**Noise Symptom - Creaking Noise from Body Front Area of the Vehicle: Replacing Upper Trailing Arm (SY 32/17)**

Model Line: **Panamera (971)**

Model Year: **As of 2017 up to 2023**

*Installation position of upper trailing arm*

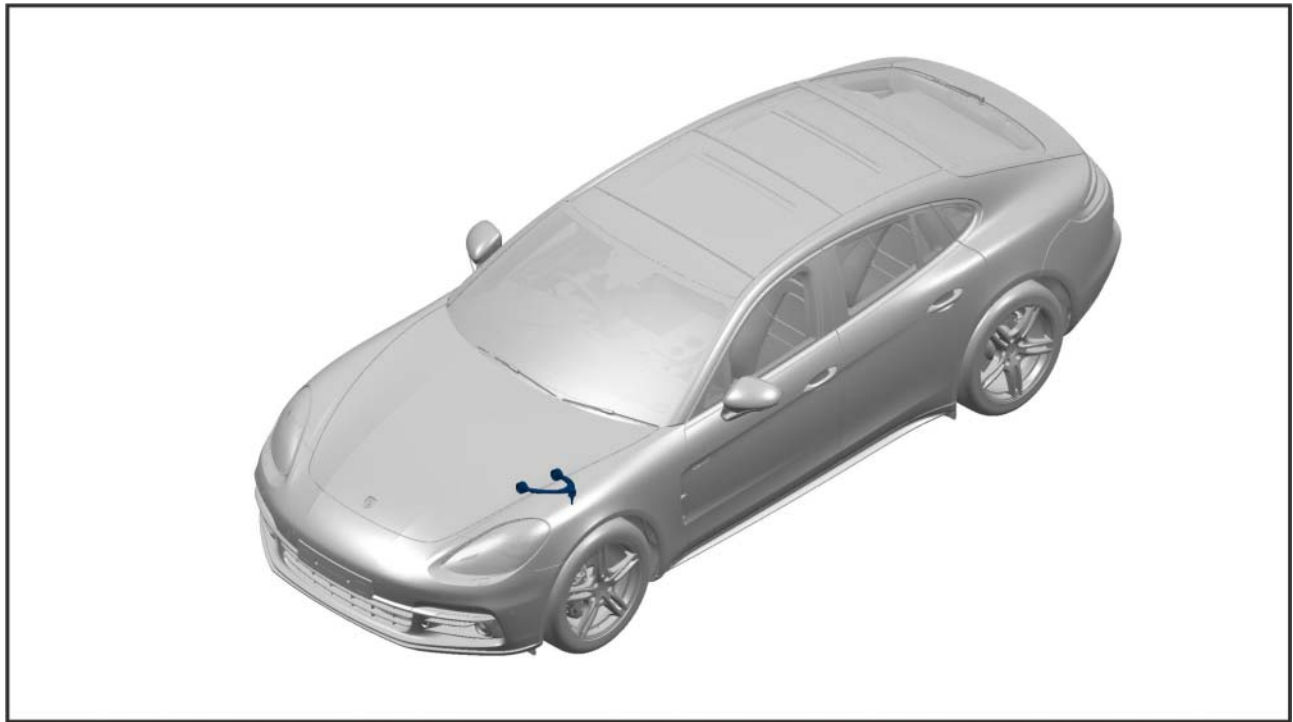
Cause: Under certain conditions, the attachment of the upper trailing arm rubber bearings to the body side can cause creaking noises.  
Temperatures below -5 °C can increase these noises.

Remedial Action: A new component status is available for the upper left and right trailing arms on the front axle.  
In the event of a comprehensible customer complaint, replace the upper left and right trailing arms on the front axle.
